**SUBJECT:** COMANCHE PEAK NUCLEAR POWER PLANT, UNITS 3 AND 4  
DOCKET NUMBERS 52-034 AND 52-035  
RESPONSE TO ENVIRONMENTAL REVIEW QUESTIONS ALT-03 AND SOC-33, AND  
SUPPLEMENTAL INFORMATION FOR QUESTION TE-04

### **Response to Request for Additional Information Regarding the Environmental Review**

**QUESTION NO.: SOC-33 (2.5.4, 4.4.3, 5.8.3)**

**Figure 1: Monthly Median Simulated Flow at Brazos River near Glen Rose Gage Scenarios A and C – 2020 Conditions**

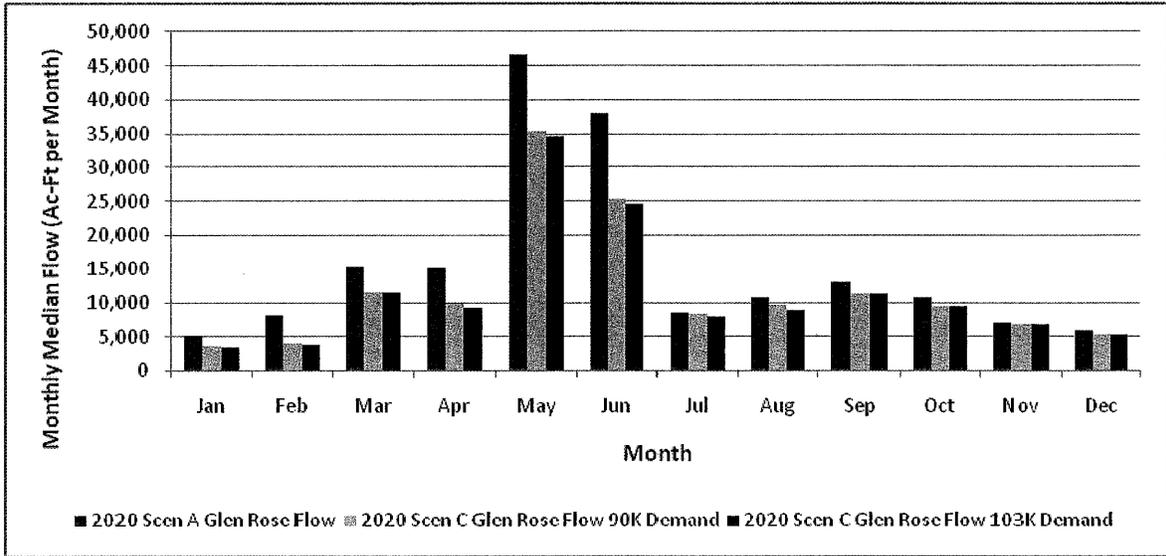
- The impacts of operating CPNPP Units 3 and 4 on water quantity and quality in the Brazos River downstream of the CPNPP site. How many miles downstream would the impacts extend?

Decreased flows in the Brazos River downstream of Lake Granbury are expected as a result of CPNPP Units 3 and 4 operational water use. This change is primarily the result of less frequent spills from Lake Granbury during periods of high flow. Modeling performed simulating the effect of Units 3 and 4 water use on downstream flows at the Brazos River Glen Rose stream gage indicates the greatest decreases in flow would be in May and June, months that typically have the greatest flow (Figure 1). From the perspective of irrigators or other small users of the river, there should be a sufficient quantity of water during periods of high flows, and a reduced frequency of flood flows may actually be beneficial. Water quantity during periods of low flow should be similar because Lake Granbury would be impounding inflows as reservoir levels drop. Increased periods of low-flow could impact irrigators or other small users and are an important factor when considering environmental justice. According to the modeling, average monthly flows less than 100 cfs would occur about 80 percent of the time before the new units come on-line (Figure 2). When the new units come on-line the frequency of these flows would increase to about 82 percent of the time. Average monthly flows of less than 10 cfs would change from occurring about 39 percent of the time to about 44 percent of the time. These changes show only a SMALL impact from an environmental justice perspective.
